**Minute No. 75**
**Report - Standing Policy Committee on Property and Development - November 30, 2004**

**Item No. 5 Subdivision and Rezoning - northwest corner of Pandora Avenue and Redonda Street**
**File DASZ 33/2004**

**RE:** **Subdivision and Rezoning - Northwest corner of Pandora Avenue and Redonda Street**
**File DASZ 33/2004**

**SUBDIVISION AND REZONING**
N/W Corner Pandora Avenue and Redonda Street
East Kildonan - Transcona Community Committee
**File No. DASZ 33/04**

**Figure 1: Schedule "A" to the report to the East Kildonan -Transcona Community Committee for File No. DASZ 33/04, dated October 25, 2004.**

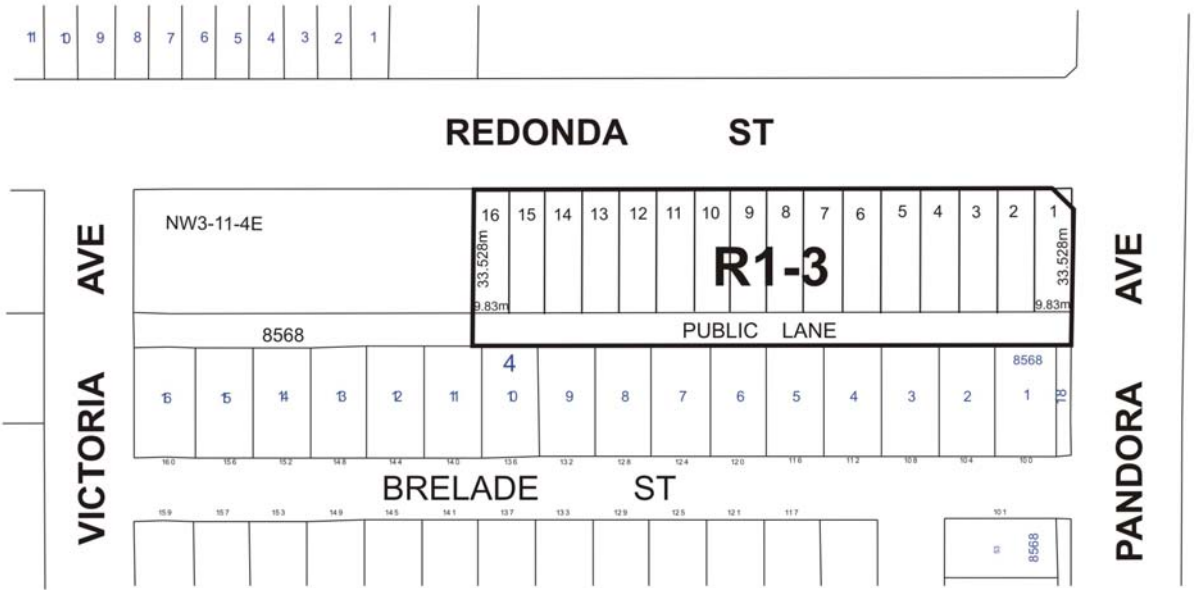
A. That the plan of subdivision be amended by requiring the developer to construct five (5) lots at 37 feet in width, and ten (10) lots at 32 feet in width, with a 31 foot buffer to be established as a Public Reserve on the south end of the development. The sequencing of the lots shall be two (2) lots of 32 feet, followed by one (1) lot of 37 feet.

iii. That Condition No. 12 be amended by substituting the words "proposed Lot 1 to the City as public open space, the area of which Lot 1" with the words "the 31 foot buffer on the south end of the development to the City as public open space, the area of which", and by adding the word "approximate" before the words "remaining five (5%) percent dedication requirement" at the end of the sentence.

A. The Developer shall construct a uniform wood barrier fence 2.0m in height, except where prohibited by The Winnipeg Zoning By-Law No. 6400/94, along the south limit of Lot 1 abutting the Public Reserve as determined by and to the satisfaction of the Director of Planning, Property and Development and the owner shall be responsible for the maintenance of the fence to the satisfaction of the Director of Planning, Property and Development.

4. That the Developer shall dedicate the 31 foot buffer on the south end of the development to the City as public open space, the area of which comprises approximately five (5%) percent of the land within the proposed subdivision and shall pay cash in lieu of dedication of land to satisfy the approximate remaining five (5%) percent dedication requirement.
